ARKANSAS NUCLEAR ONE - UNIT NO.1

AMENDMENT TO FACILITY OPERATING LICENSE

Amendment No. 67  
License No. DPR-51

ATTACHMENT TO LICENSE AMENDMENT NO. 67

Figure 2.1-2

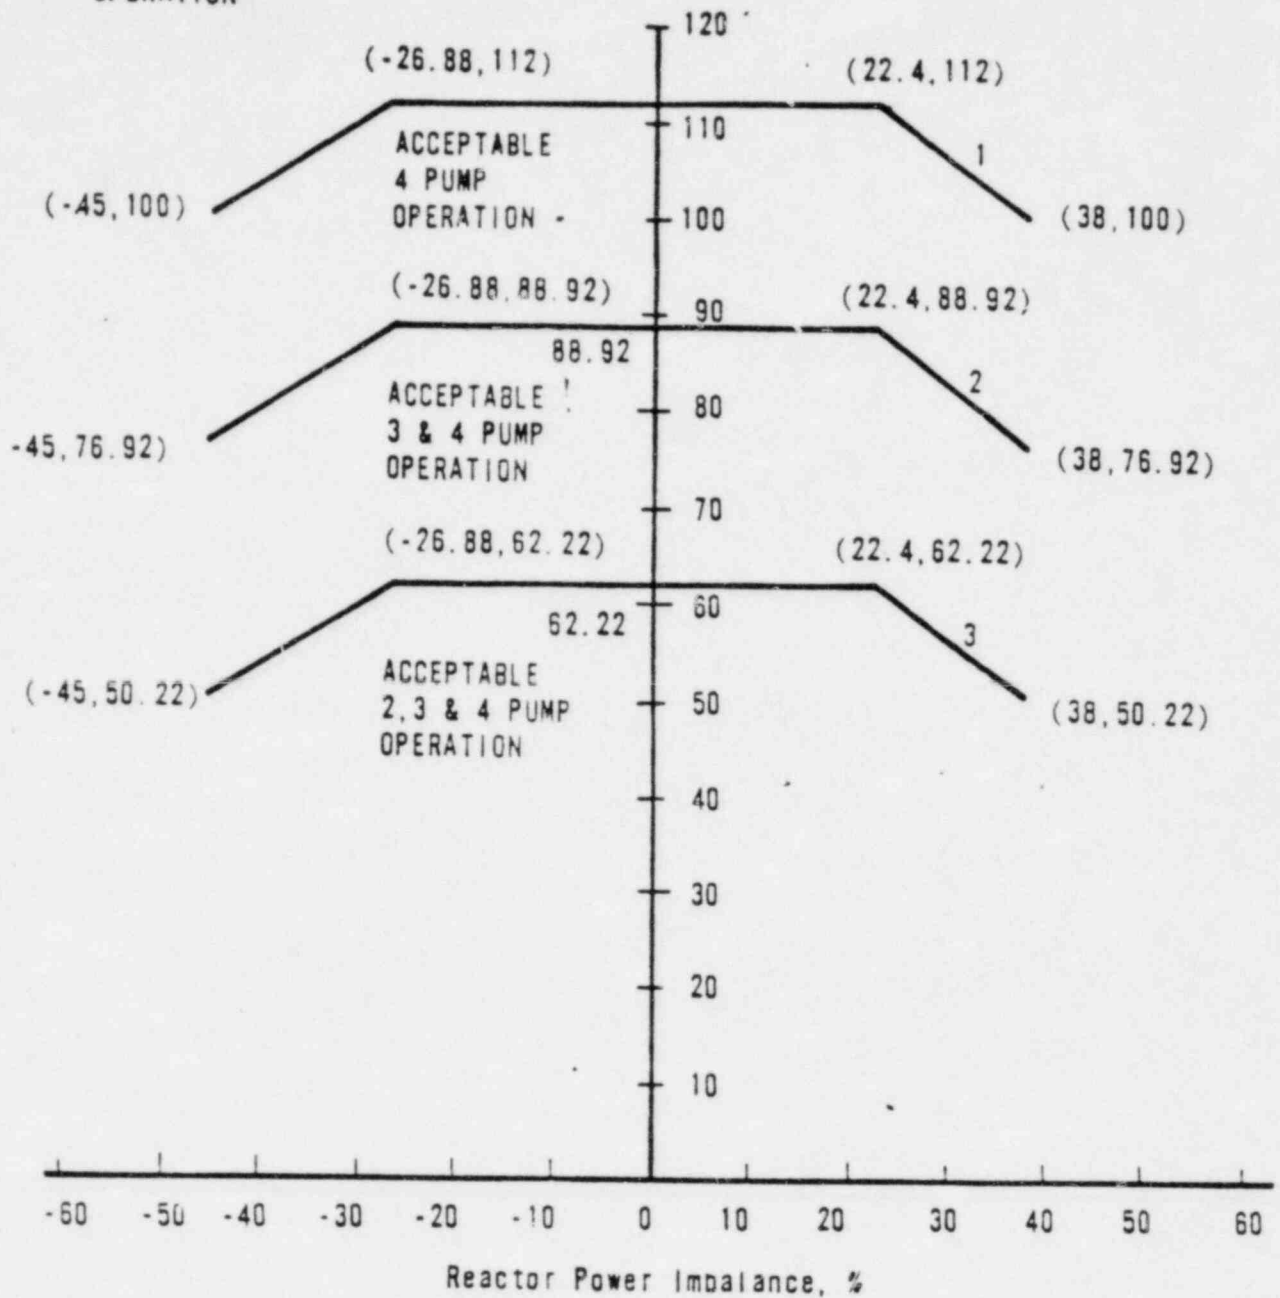
For each curve of Figure 2.1-3, a pressure-temperature point above and to the left of the curve would result in a DNBR greater than 1.3 or a local quality at the point of minimum DNBR less than 22 percent for that particular reactor coolant pump situation. Curves 1 & 2 of Figure 2.1-3 are the most restrictive because any pressure/temperature point above and to the left of this curve will be above and to the left of the other curve.

Figure 2 3-1

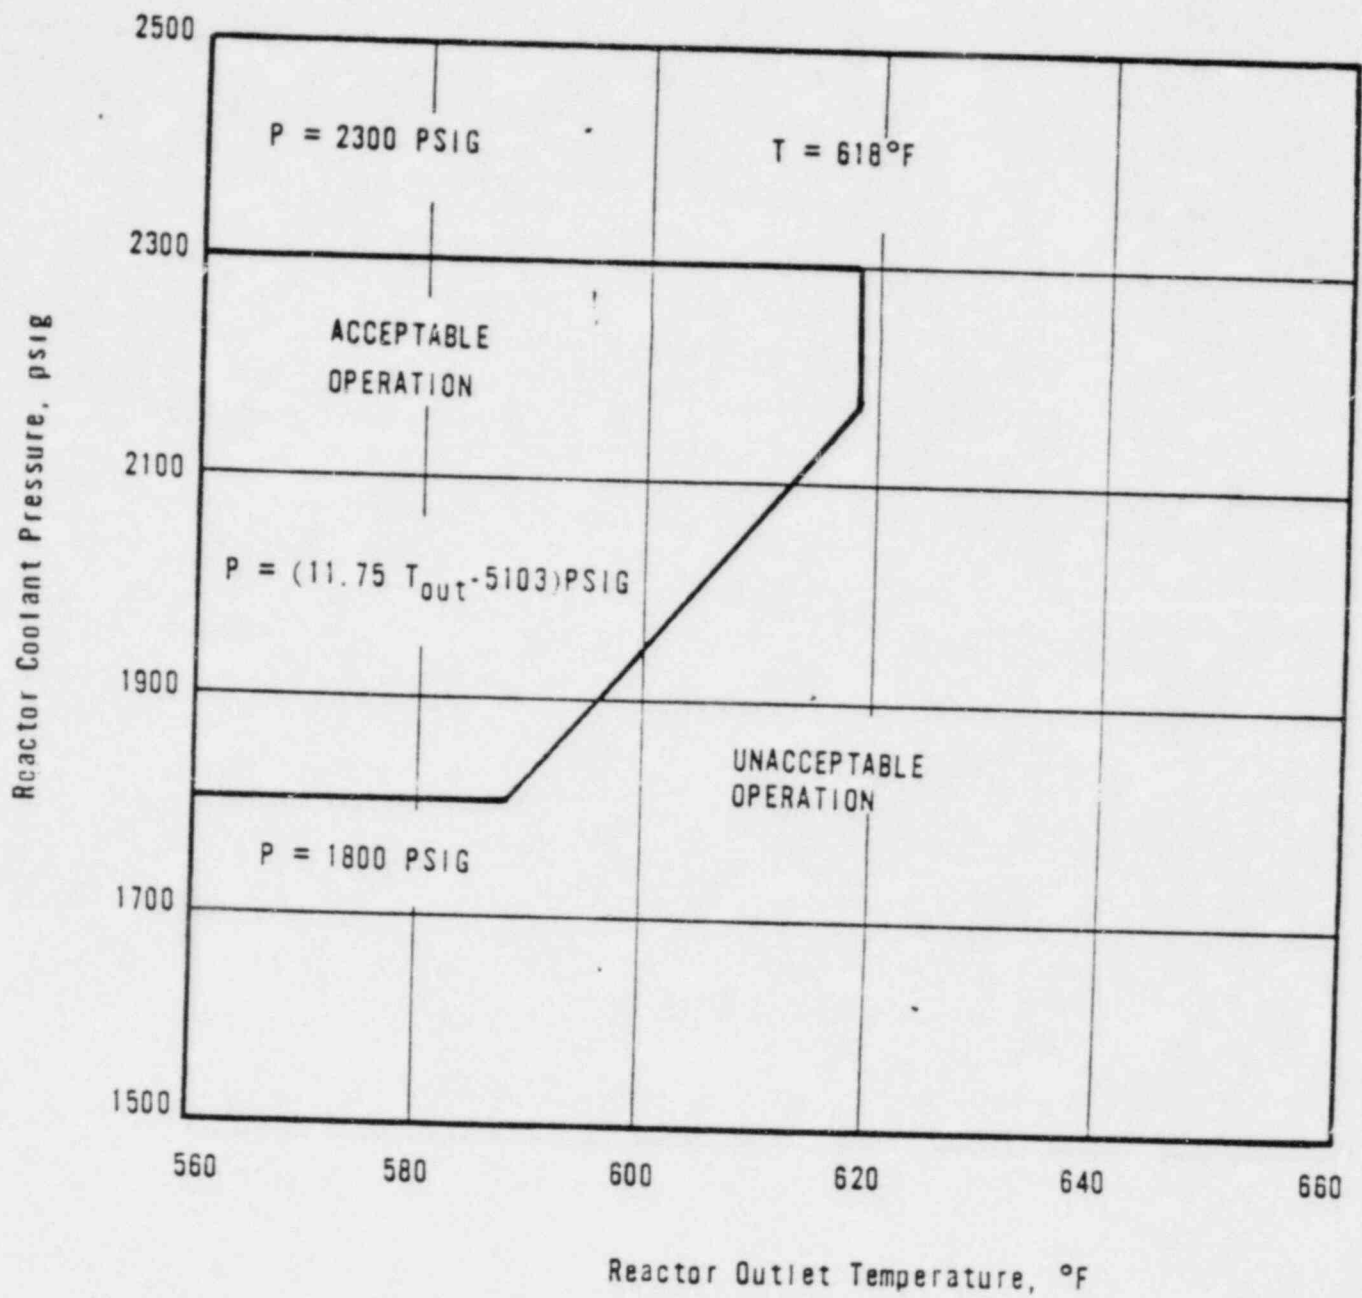
During a startup accident from low power or a slow rod withdrawal from high power, the system high-pressure trip setpoint is reached before the nuclear overpower trip setpoint. The trip setting limit shown in Figure 2.3-1 for high RCS pressure (2300 psig) has been established to maintain the system pressure below the safety limit (2750 psig) for any design transient.(2)

The low-pressure (1800 psig) and variable low-pressure ( $11.75 T_{out} - 5103$ ) trip setpoints shown in Figure 2.3-1 have been established to maintain the DNB ratio greater than or equal to 1.3 for those design accidents that result in a pressure reduction.(2,3)

The high reactor coolant outlet temperature trip setting limit (618F) shown in Figure 2.3-1 has been established to prevent excessive core coolant temperatures in the operating range. Due to calibration and instrumentation errors, the safety analysis used a trip setpoint of 620F.

Figure 2.3-2

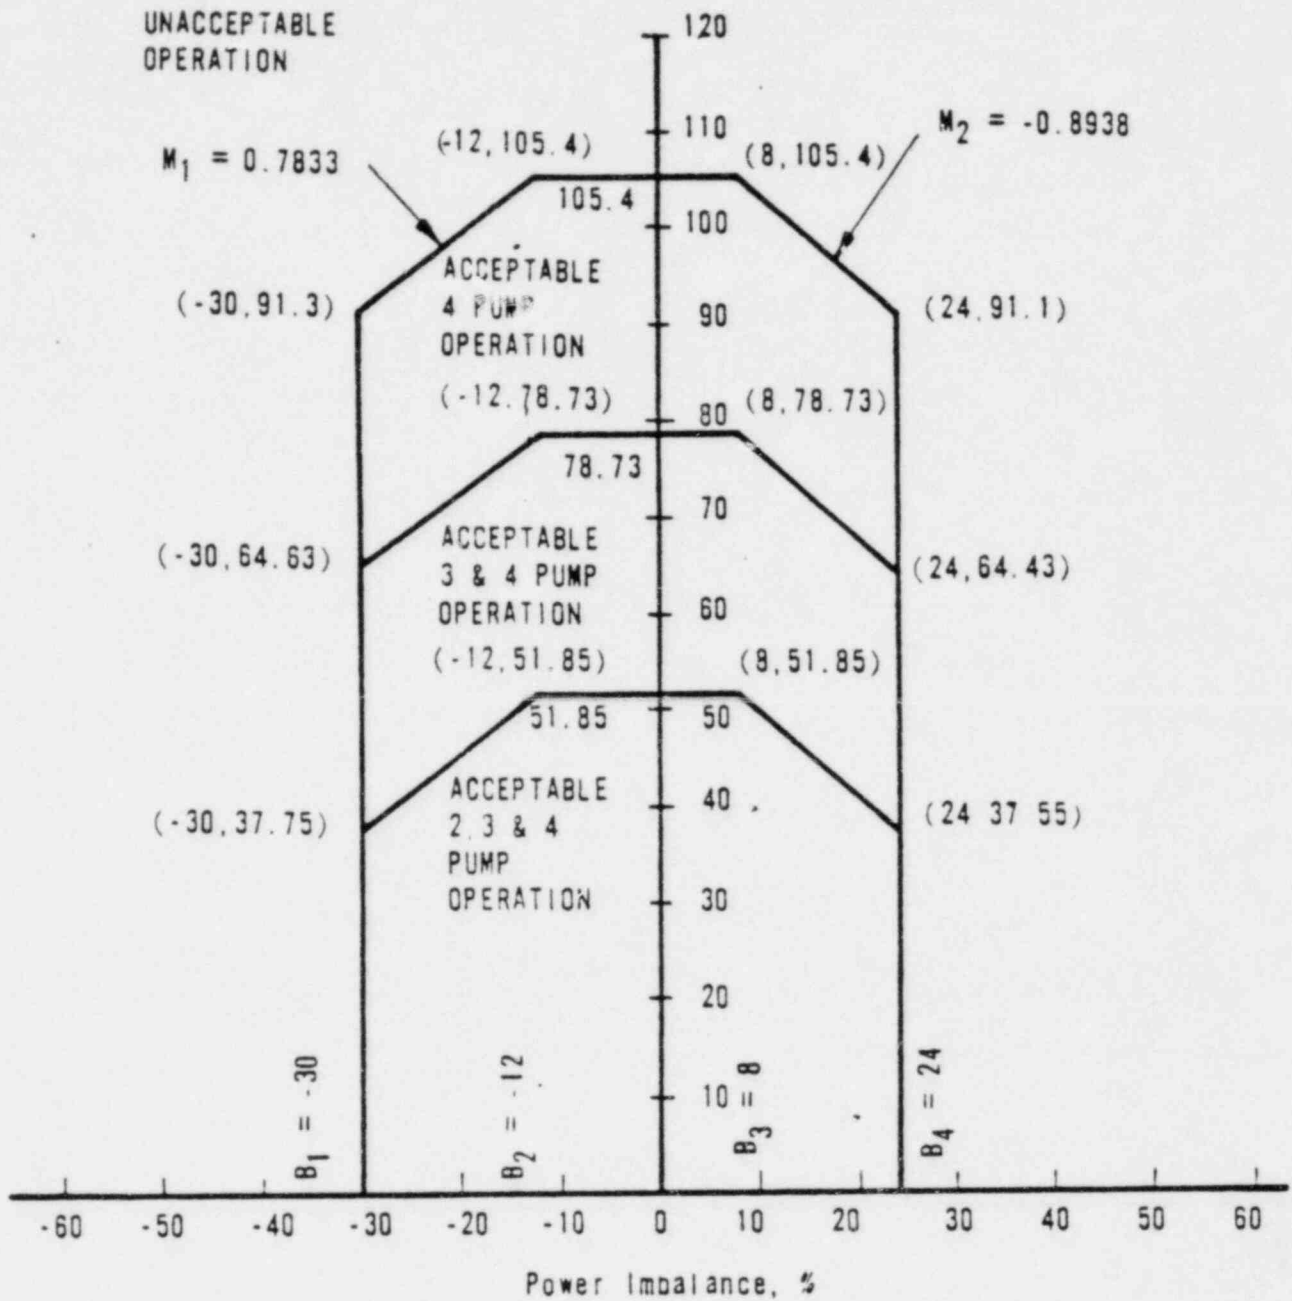
- 2.3.1 The reactor protection system trip setting limits and the permissible bypasses for the instrument channels shall be as stated in Table 2.3-1 and Figure 2.3-2.
